# CITY OF ALBUQUERQUE

**RE: Cibola Loop Multigenerational Center  
Revised Conceptual Grading & Drainage  
Plans Engineer's Stamp Date: 04/08/24  
Hydrology File: A13D025**

**PROJECT TITLE:**  
**COA CIBOLA LOOP MULTIGENERATIONAL CENTER**

**DRAWING TITLE:** CONCEPTUAL GRADING AND DRAINAGE PLAN

Sheet  
**CG-001**

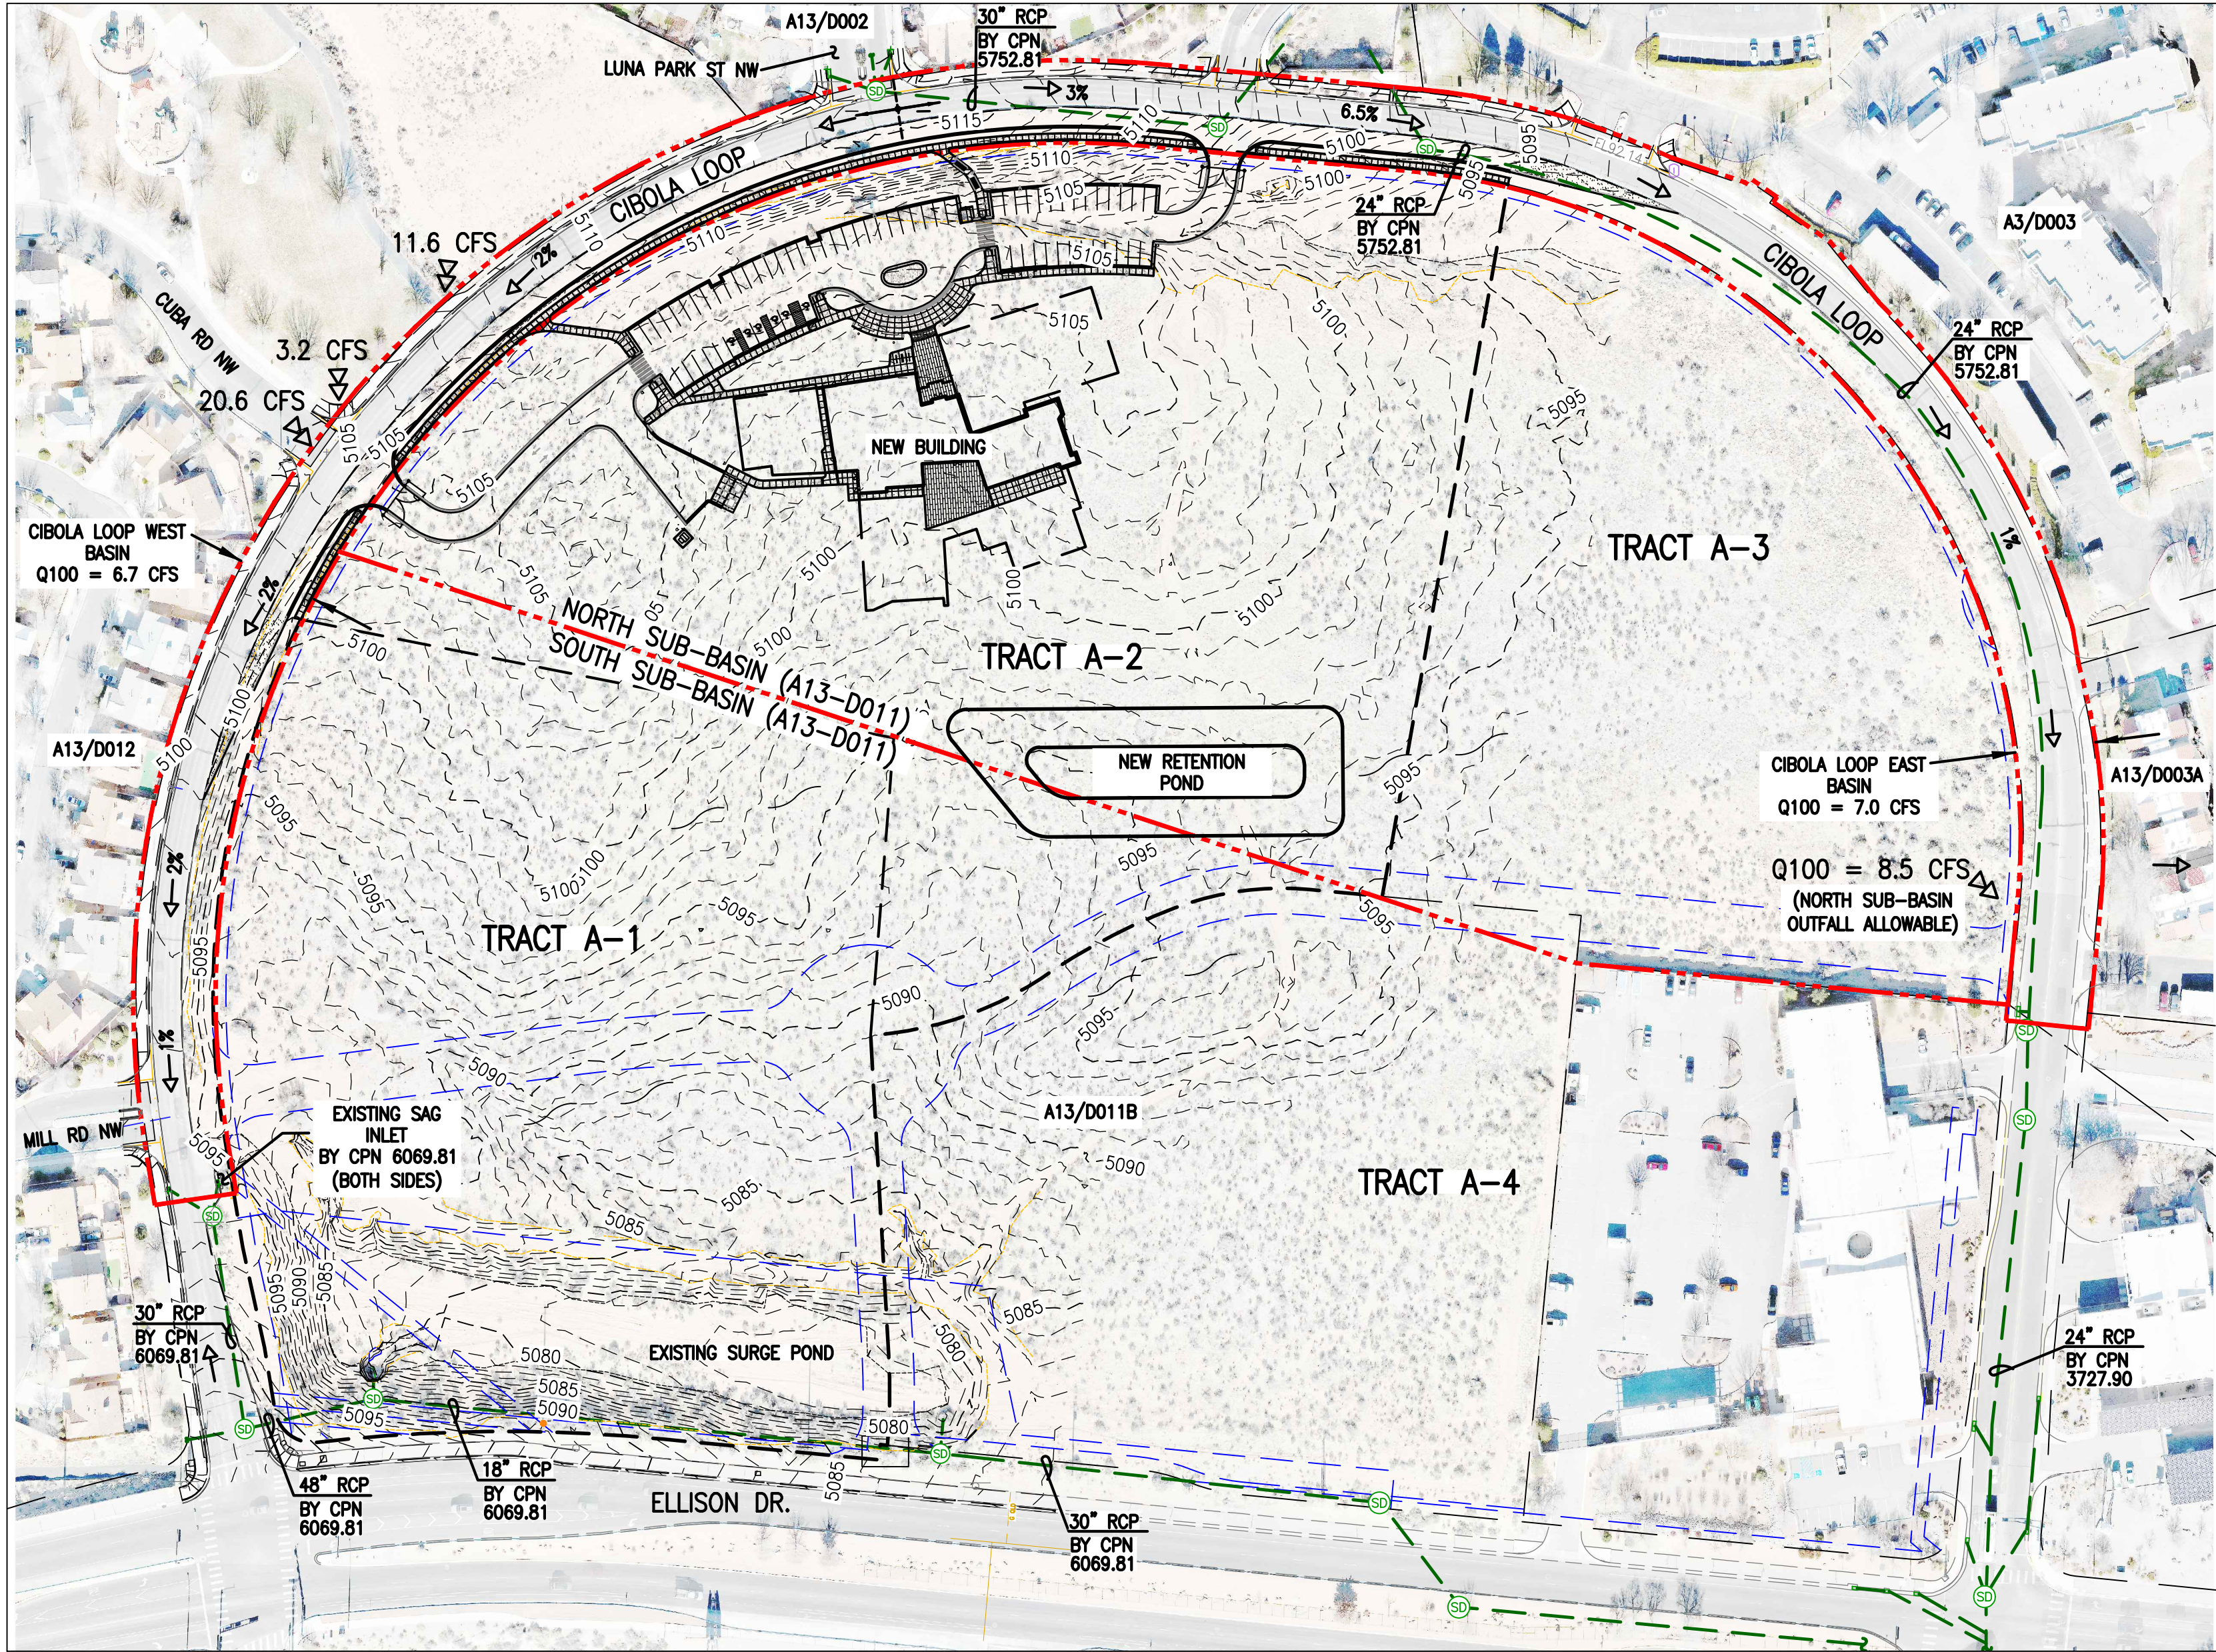
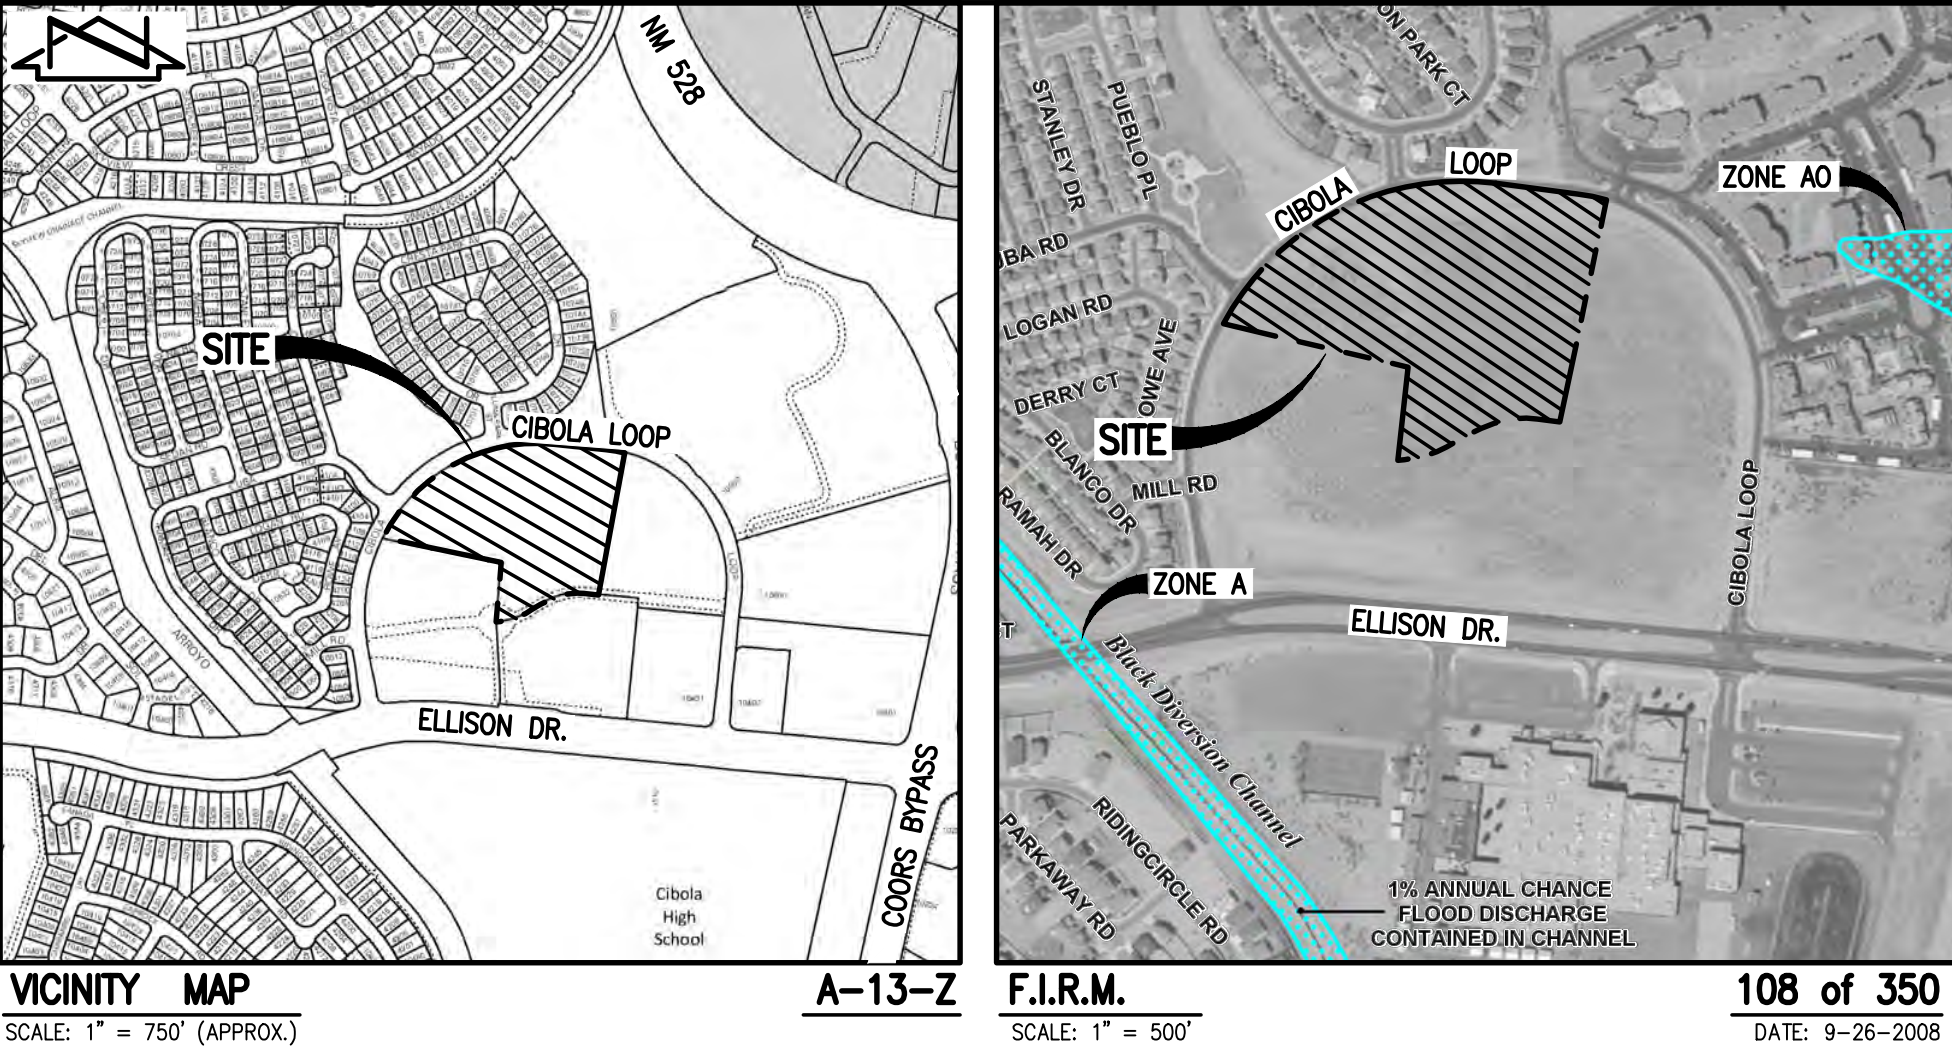
1. Please submit a more detailed Grading & Drainage Plan to Hydrology for review and approval. This digital (.pdf) is emailed to [PLNDRS@cabq.gov](mailto:PLNDRS@cabq.gov) along with the Drainage Transportation Information Sheet.

City of Albuquerque  
Planning Department  
Development Review Services  
**PRELIMINARY APPROVED**  
DATE: 06/17/24  
BY: *Renee Brumfield*  
Hydrology: A130025  
THESE PLANS AND/OR REPORT ARE  
CONCEPTUAL. MORE INFORMATION MAY  
BE NEEDED IN THEM AND IS SUBMITTED TO  
HYDROLOGY FOR BUILDING PERMIT APPROVAL.
